From: Dunn, John [/O=EXCHANGELABS/OU=EXCHANGE ADMINISTRATIVE GROUP (FYDIBOHF23SPDLT)/CN=RECIPIENTS/CN=3A95618CC07745F9A4B30B3F654CD05D-DUNN, JOHN]
Sent: 12/5/2019 5:54:43 PM
To: Jennifer Campbell [Jennifer.Campbell@mdc.mo.gov]
Subject: RE: Comments on Ameren Labadie 316(a) Variance Request

From: Dunn, John [mailto:Dunn.John@epa.gov]
Sent: Wednesday, December 04, 2019 9:41 AM
To: Hackler, Pam <pam.hackler@dnr.mo.gov>
Cc: Wieberg, Chris <chris.wieberg@dnr.mo.gov>; Michael Abbott - MDNR <michael.abbott@dnr.mo.gov>; heather.peters@dnr.mo.gov; karen_herrington@fws.gov; Jennifer Campbell <jennifer.Campbell@mdc.mo.gov>; Madden, Venessa <Madden.Venessa@epa.gov>; Curtis, Glenn <curtis.glenn@epa.gov>
Subject: Comments on Ameren Labadie 316(a) Variance Request

EPA has two sets of comments on the proposed variance. Comments on the Biological Study are attached, and NPDES permit based comments are below:

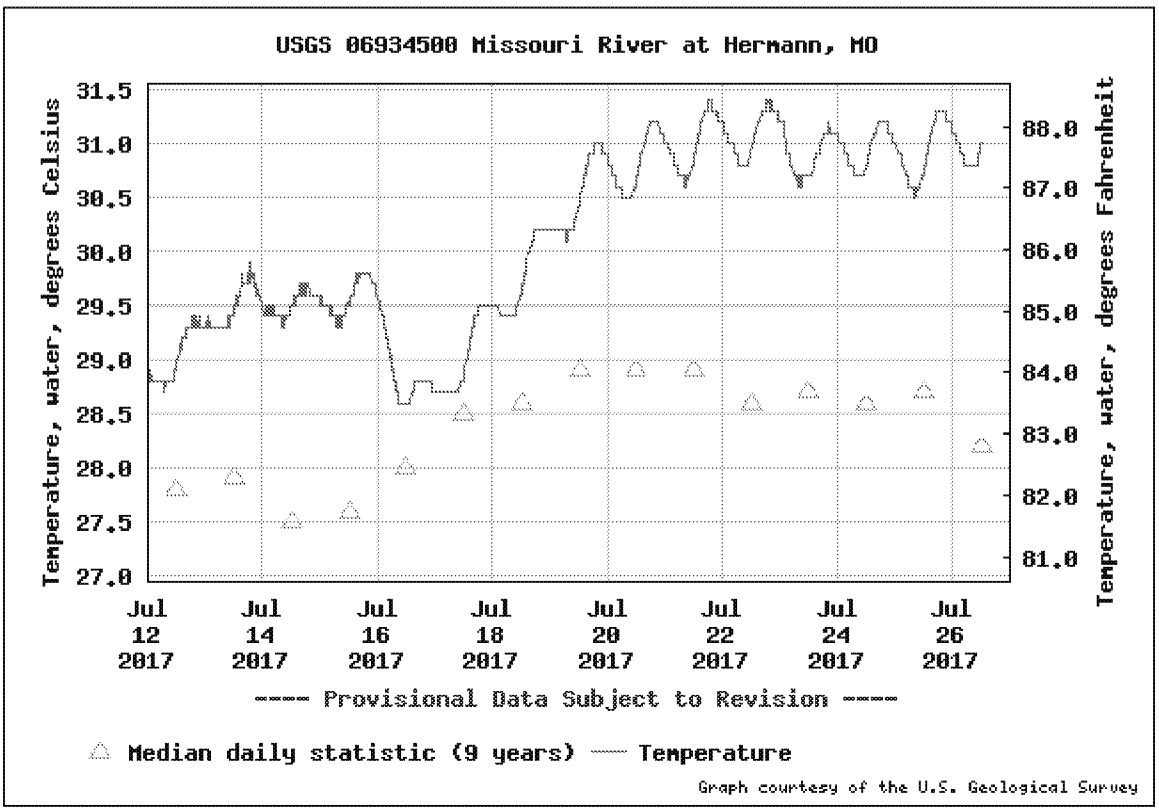
Equations for deriving TDP are calculated to many significant digits but monitoring in the current permit is only required once daily. During heat events, stream temperature can vary by up to 1.5°F in a given day. See 2017 data in the graph below.

The permit should assure that monitoring precision matches up with the detailed nature of the modeling. It should be noted that the USGS gage at Hermann, the data source for the permit, monitors Flow and

Temperature every 15 minutes. Temperature can be measured inexpensively by calibrated thermistors feeding data to a computer that calculates TDP and estimated temperature at the edge of the RMZ. Continuous monitoring at this frequency would generate unneeded data, but high frequency monitoring when variance conditions are approached could create important data sets for future consideration. In any case, all data used in the model equations should be time synchronized.
